APPLICATION NO.	FILING DATE	FIRST NAMED INVENTOR	ATTORNEY DOCKET NO.	CONFIRMATION NO.
09/869,784	10/16/2001	Toshiyasu Ito	04208.0112	8751

Office Action Summary	Application No.	Applicant(s)	
	09/869,784	ITO ET AL.	
	Examiner	Art Unit	
	Felix O. Figueroa	2833

DETAILED ACTION

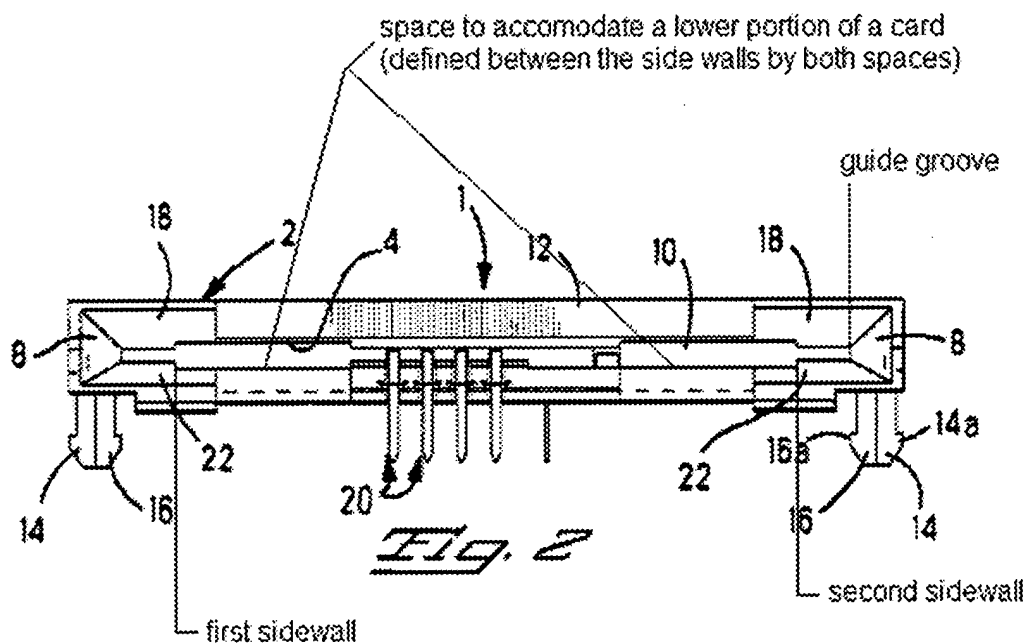
Asakawa discloses a card connector configure to hold a first card and configure to hold a second card, and comprising: a pair of guide grooves (see following figure) formed on both sidewalls of a connector housing (2); and first and second sidewalls (see following figure), and a base plate with a plurality of contact terminals (20) arranged in the base plate to couple with contact of a bottom surface of a card. Asakawa also discloses a first space defined between the guide grooves, and a second space defined by the sidewalls; wherein no portion of the base extends into the second space; the second space (see following figure) located below the first space, and the second space configure to accommodate a lower portion of a first card.

Please note that the space is defined by both spaces as shown in the earlier presented figure.

In response to Applicant's arguments that Asakawa does not teach a second space 'defined by said first and second side walls' where 'no portion of said base plate extends into said second space' because "partitions 28, which comprise portions of the base plate of housing 2, sit between the alleged first and second side walls", please note that the fact that the partition 28 sit between the first and second side wall does not means that it "extends into" the second space. Please note that in the figure above, the space is defined by both spaces as shown. Accordingly, partitions 28 do not extend into the space itself, as defined.
